April 3<sup>rd</sup>, 2023

JDE Project 1519

**RE: Traffic Impact Study - Addendum**  
**405 Essa Road Development, City of Barrie**

1 CONTEXT PLAN  
A001 1 : 1000

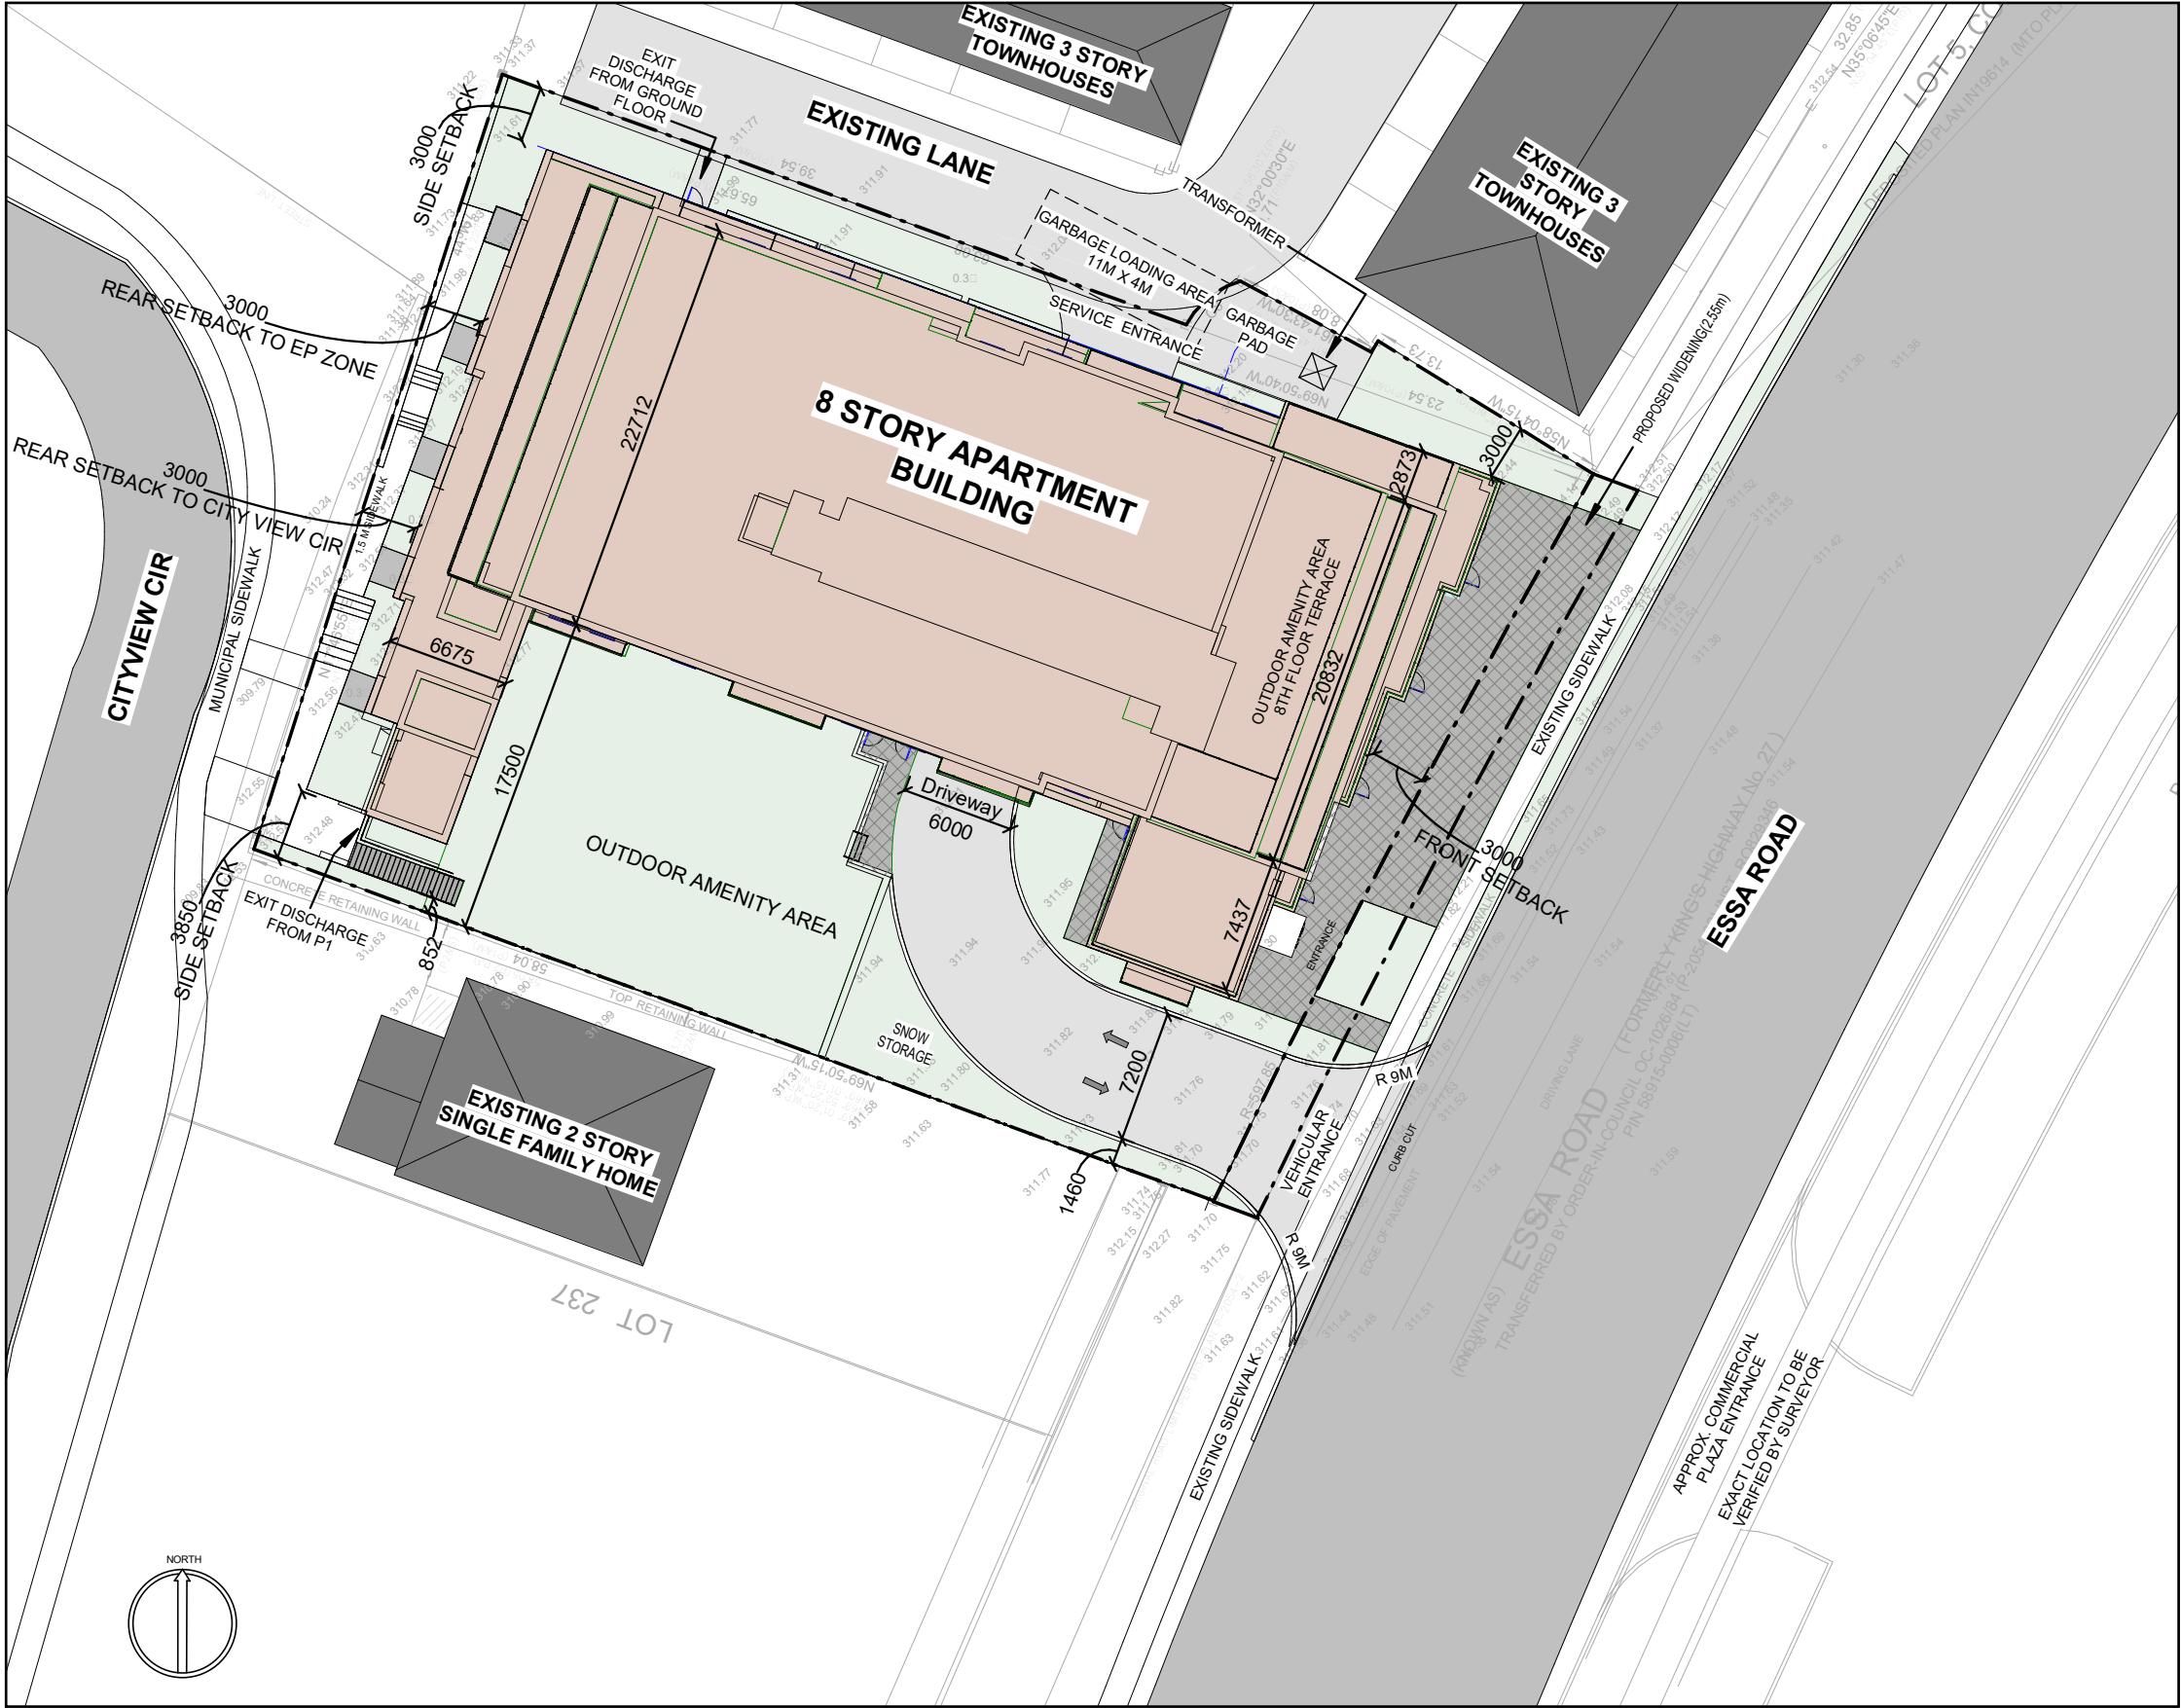
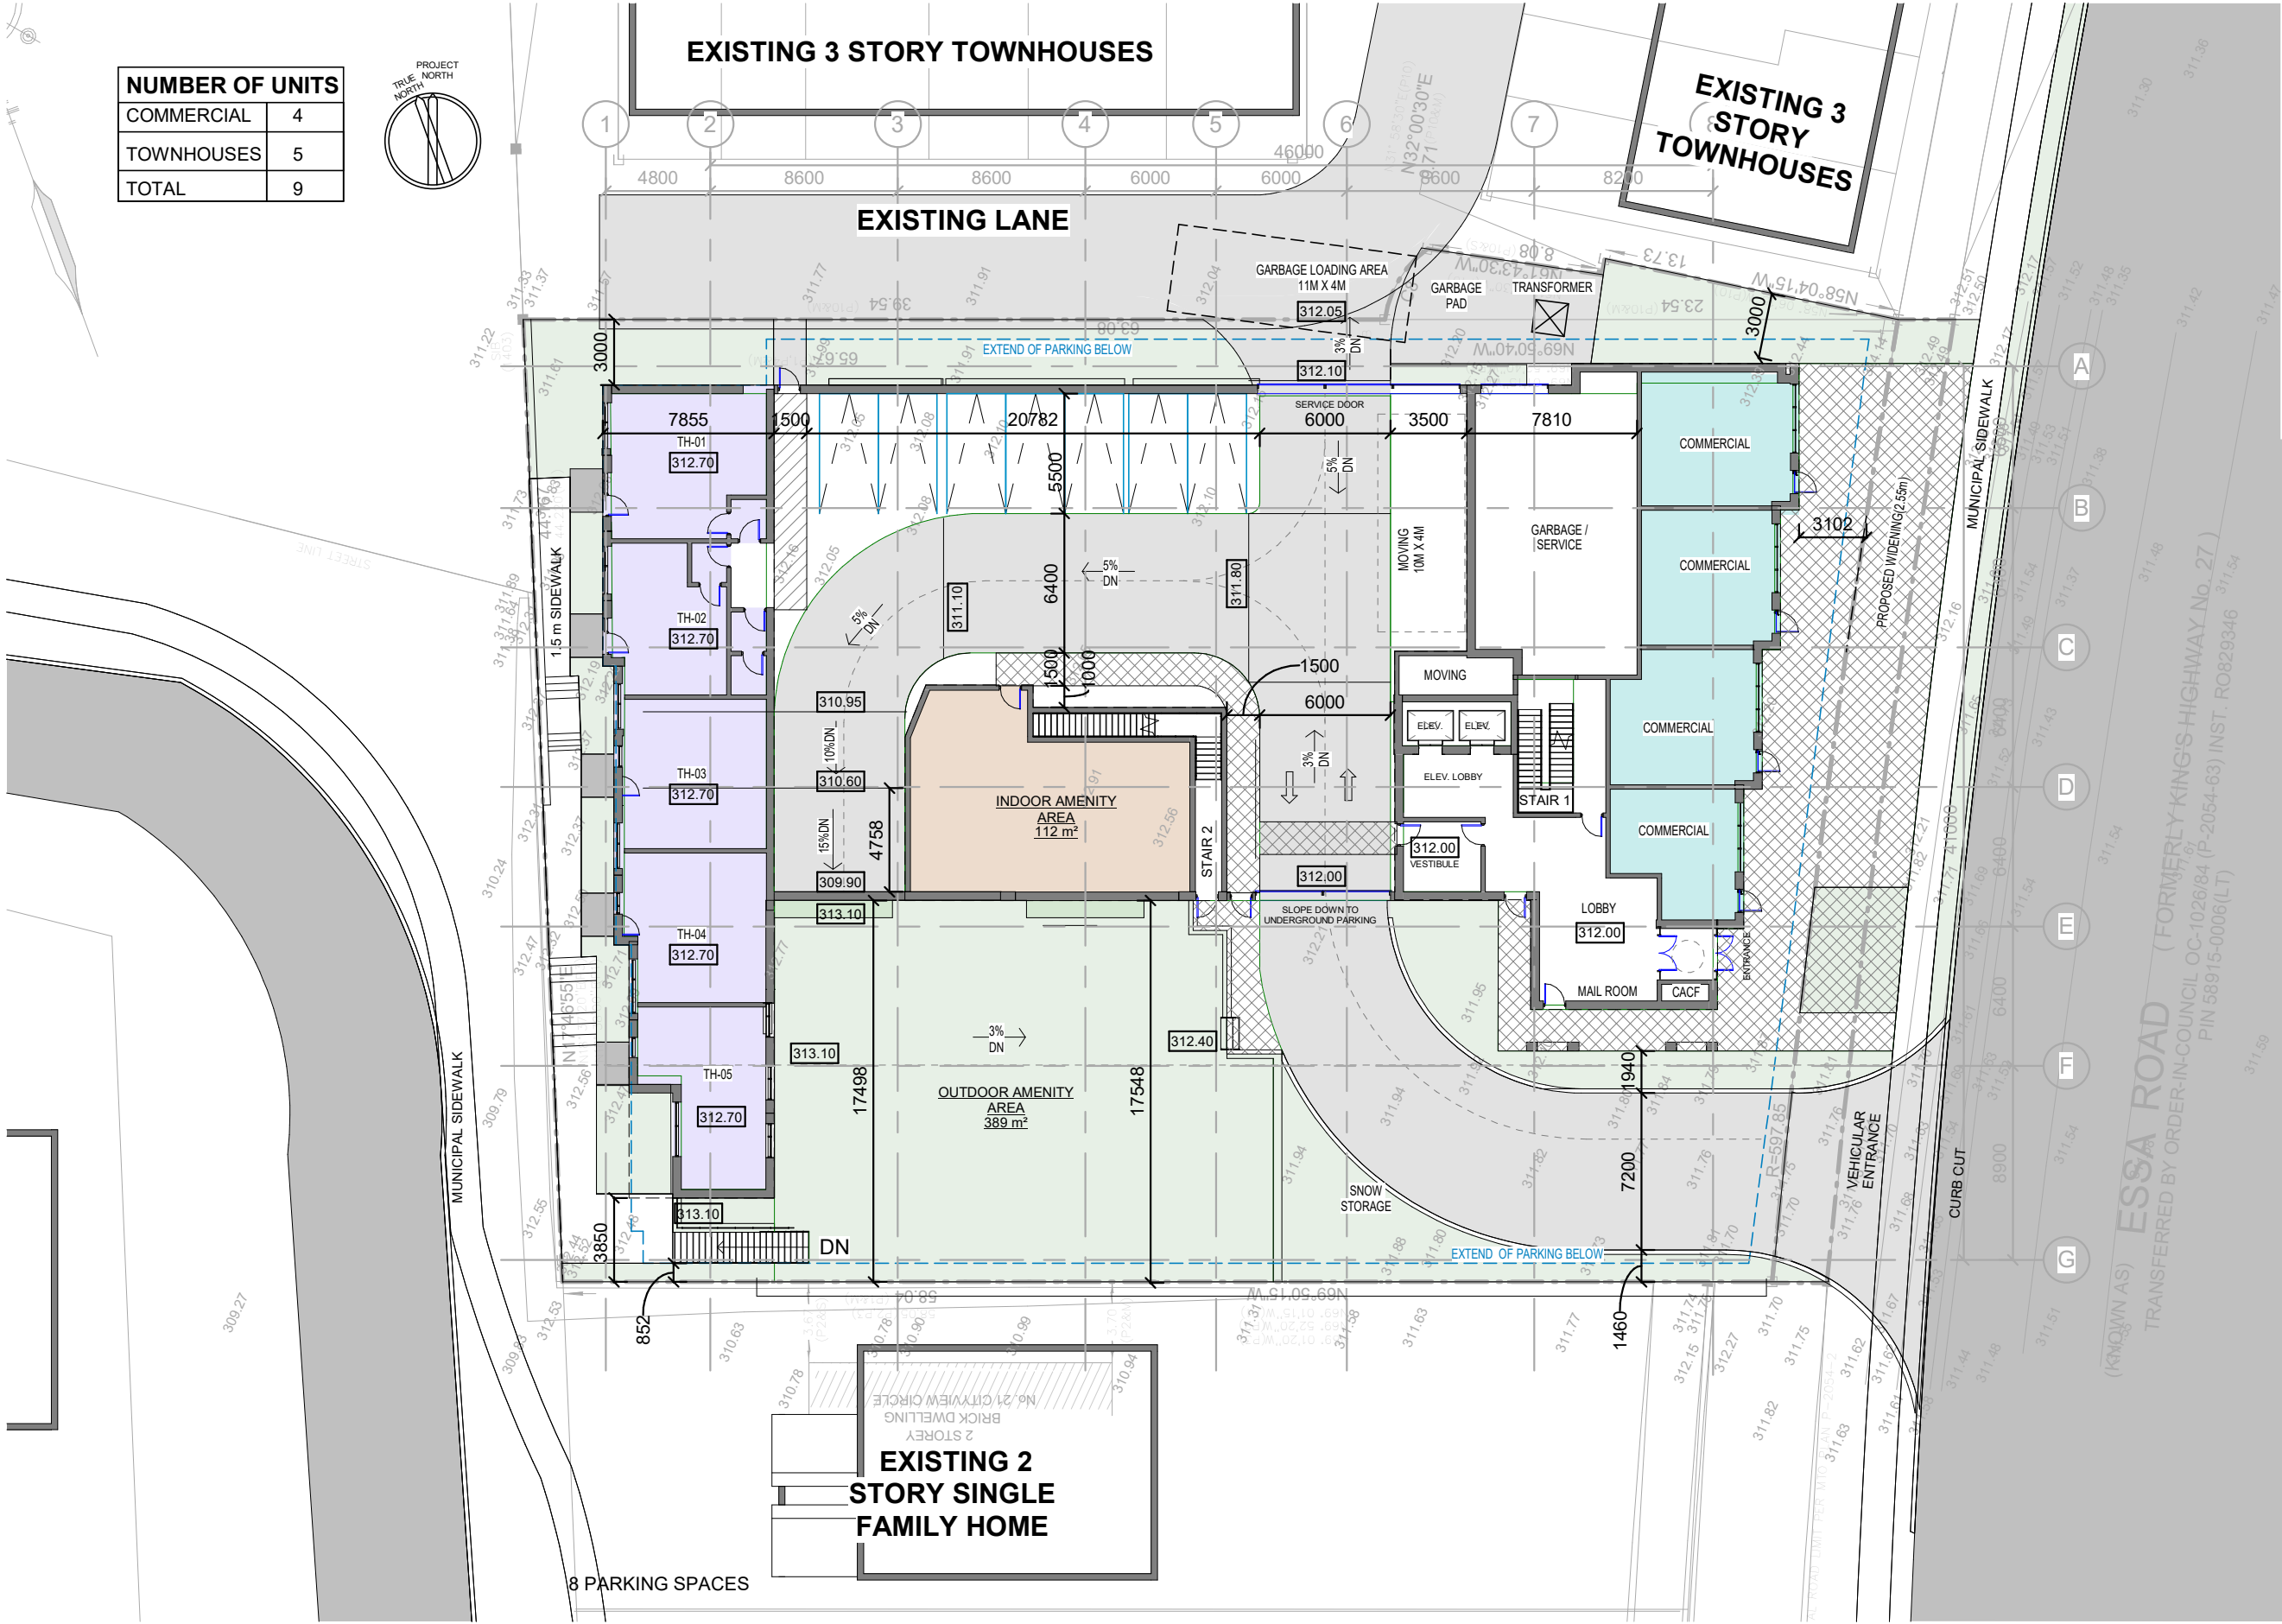
The Site Access in the revised Site Plan has been relocated slightly further south to improve the alignment with the existing commercial driveway on the east side of Essa Road. The revised location of the Site Access still meets the minimum spacing requirements and sight distance requirements, as outlined in the TIS. As a result, there is no change to the recommendations and conclusions presented in the TIS.

The width of the throat for the Site Access in the revised Site Plan has been increased from 6.0 metres to 7.2 metres. For the reasons outlined in the TIS, no operational or traffic safety issues are anticipated at the Site Access as a result of the proposed driveway throat width.

The internal driveway aisles have been increased from 6.0 metres to 6.4 metres where the driveway aisle is adjacent to parking stalls. The proposed internal driveways can accommodate the required vehicle turning movements and will not result in any operational issues.

The revised Site Plan includes a service access via an easement within the existing residential development to the north. This access will be controlled by an overhead service door and will not be accessible for private vehicle access. This service access will allow waste collection vehicles to enter and exit the site in a forward motion.
